# MONITORING YEAR 2 ANNUAL REPORT

## CROSS CREEK RANCH SITE

DMS Project No. 100138

RE: Cross Creek Ranch Site – Monitoring Year 2 Draft Report  
Montgomery County, NC  
Yadkin River Basin – CU# 03040104  
DMS Project ID No. 100138  
Contract # 7879-01

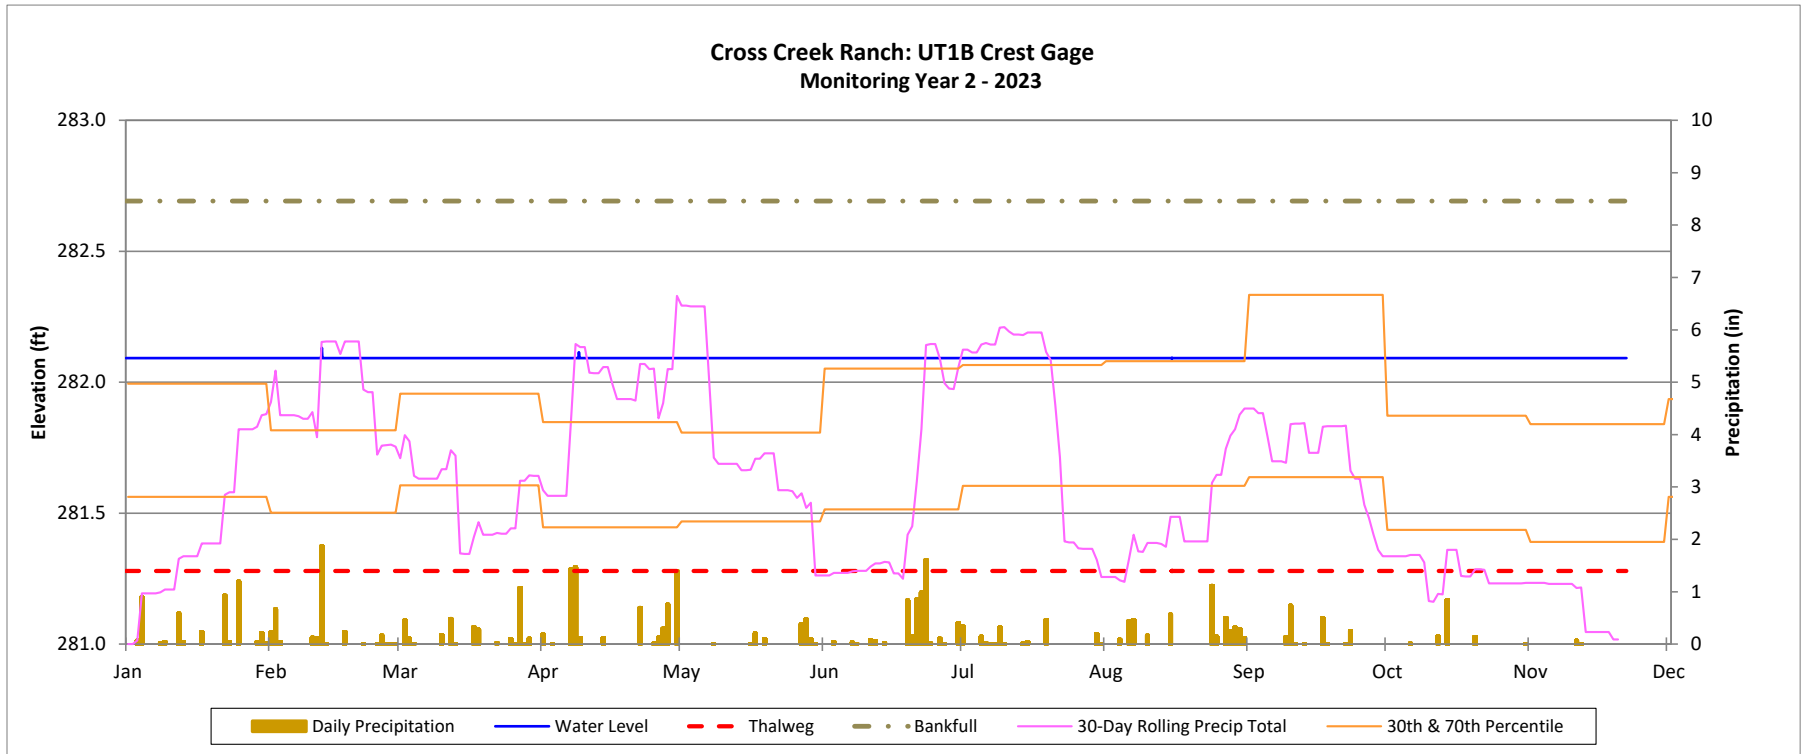
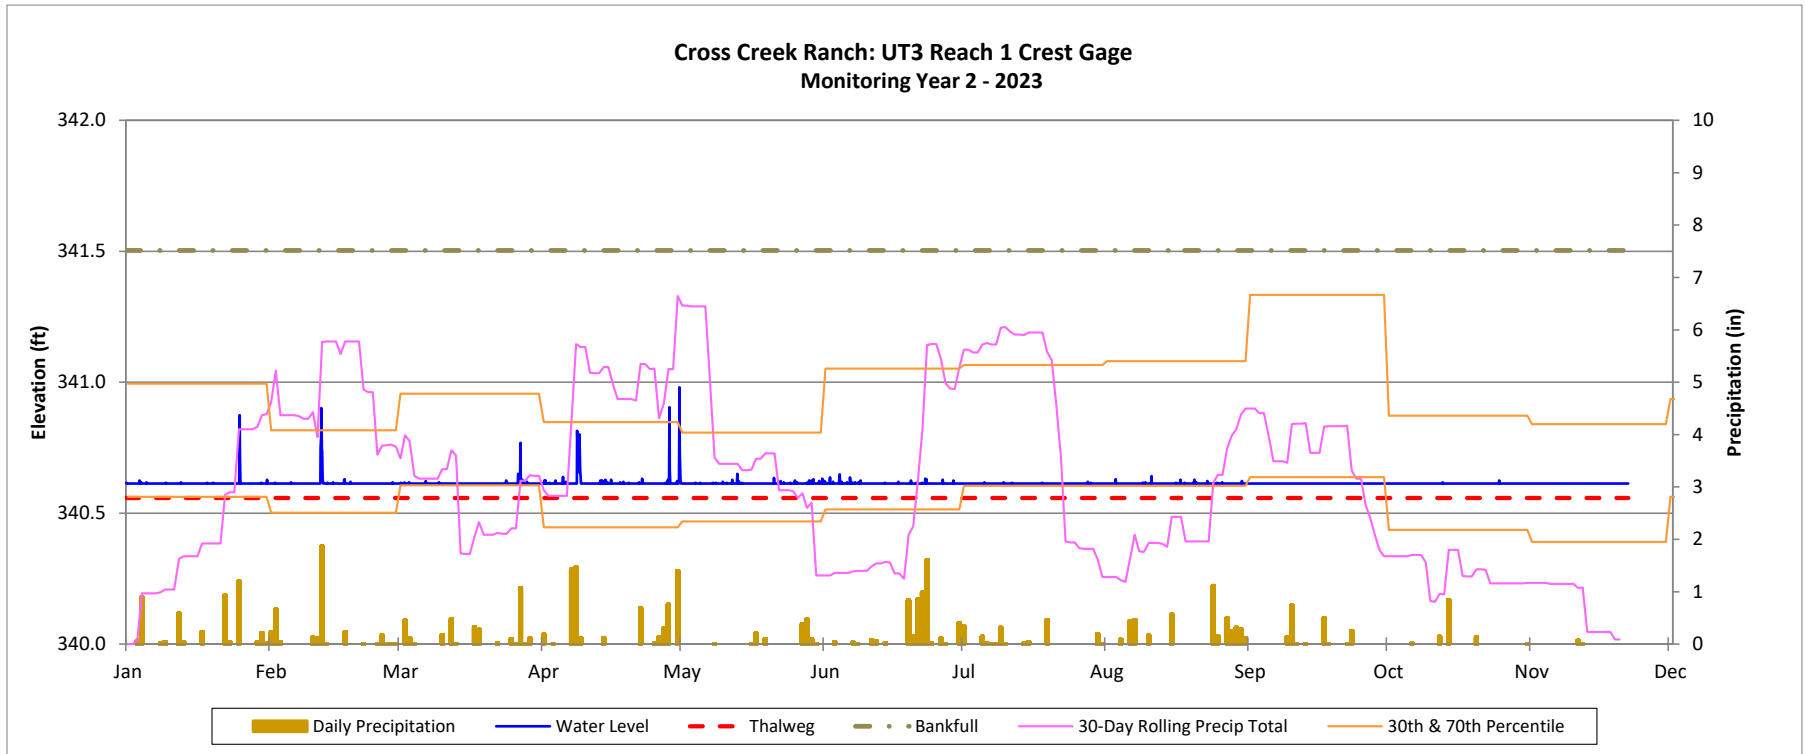
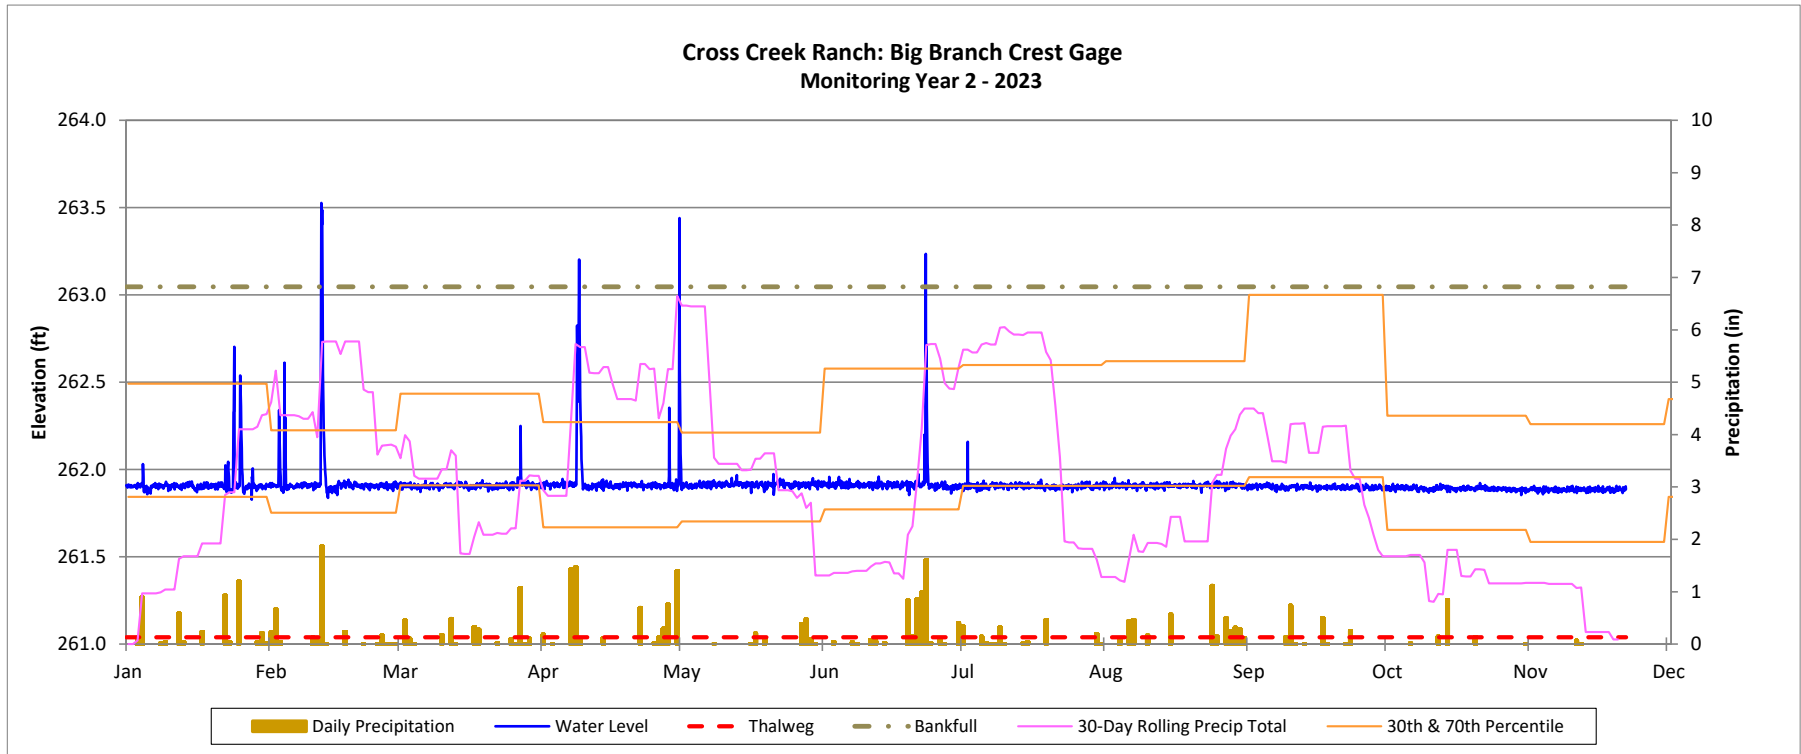
**DMS' comment: Appendix D. Hydrology Data - UT1B Crest Gage: The pressure transducer appears to be set above the base flow water level and is continually dry. The gage should be set at a lower elevation to show changes in stream stage throughout the year.**

*Wildlands' response: The crest gage on UT1B will be re-installed at a lower elevation in the same location in MY3 to show the changes in the stream stage throughout the year.*

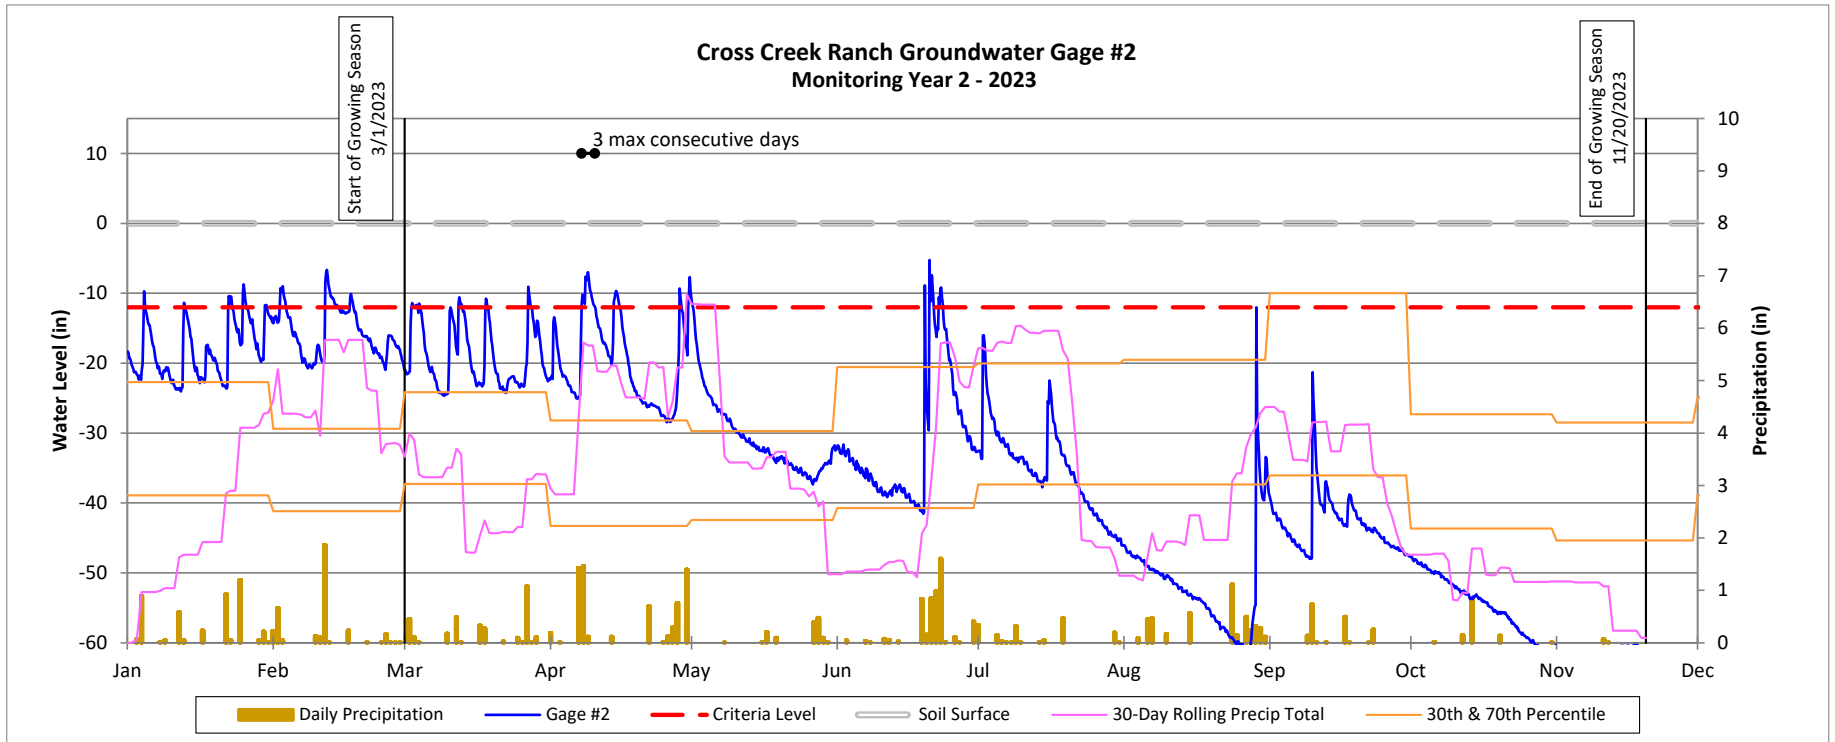
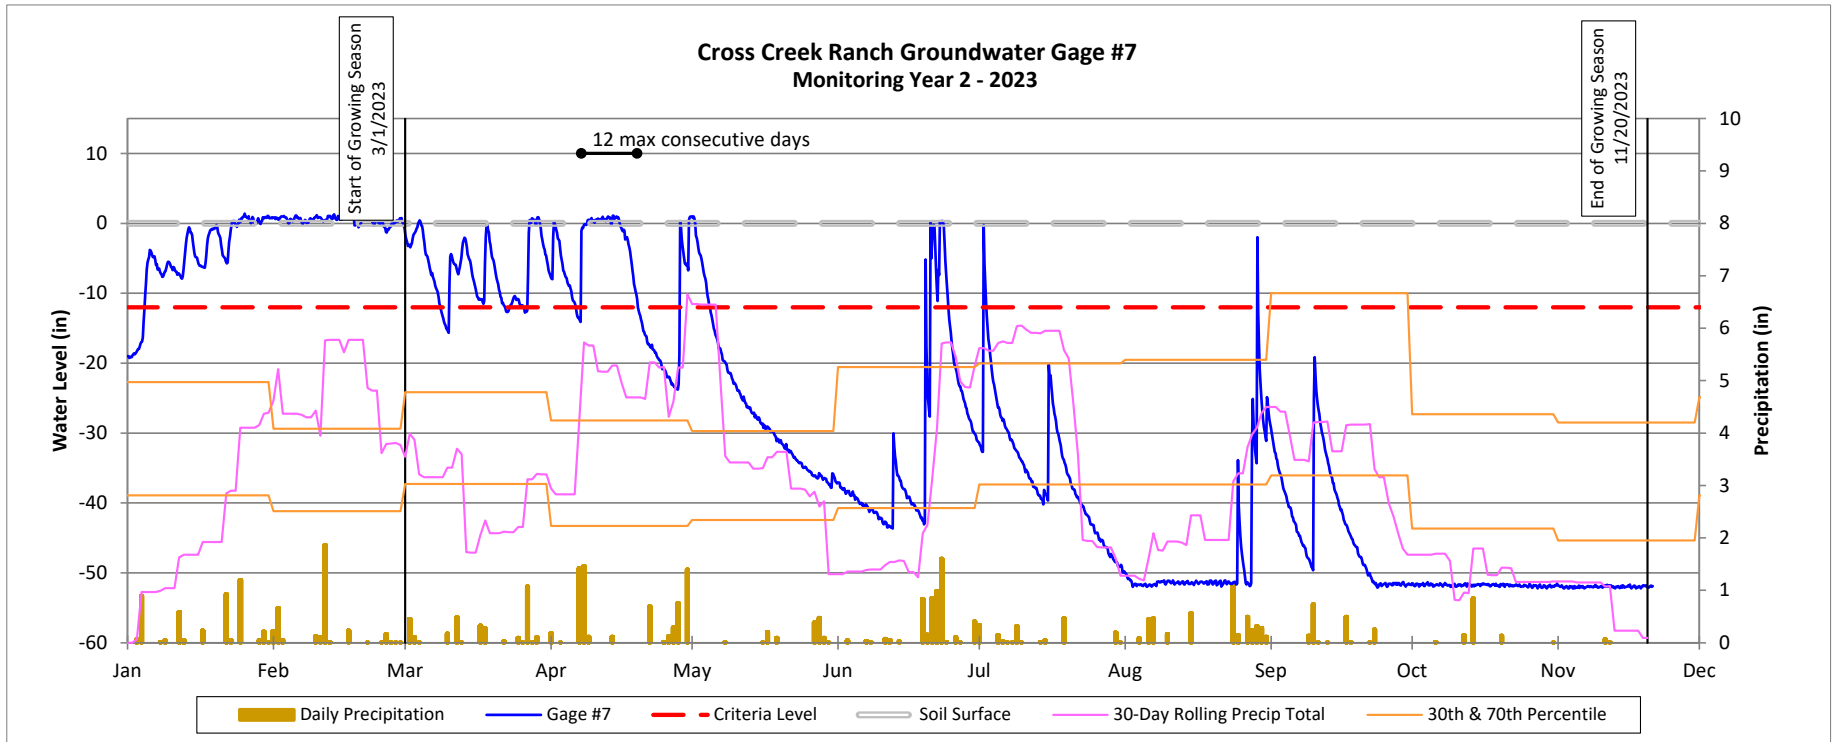
**DMS' comment: 2.6 Wetland Hydrology Assessment: GWGs 2 and 7 did not meet their hydroperiods again during MY2. The wells are geographically positioned near the center of their respective wetland polygons but may be located on small areas of higher elevation based on field observations and adjacent well measurements. Please verify the well locations are hydrologically representative of their surrounding wetland areas.**

*Wildlands' response: To ensure that the hydrologic data collected for the proposed wetlands surrounding GWG2 and GWG7 is representative of each area's elevation, Wildlands will install an additional well near each existing gage. The wells will be installed in MY3 prior to the onset of the growing season. Hydrologic data for the additional wells and their locations will be included in the MY3 report. Wildlands will continue to collect hydrologic data from GWG2 and GWG7, as well as the newly installed wells throughout the remainder of the 7-year monitoring period.*
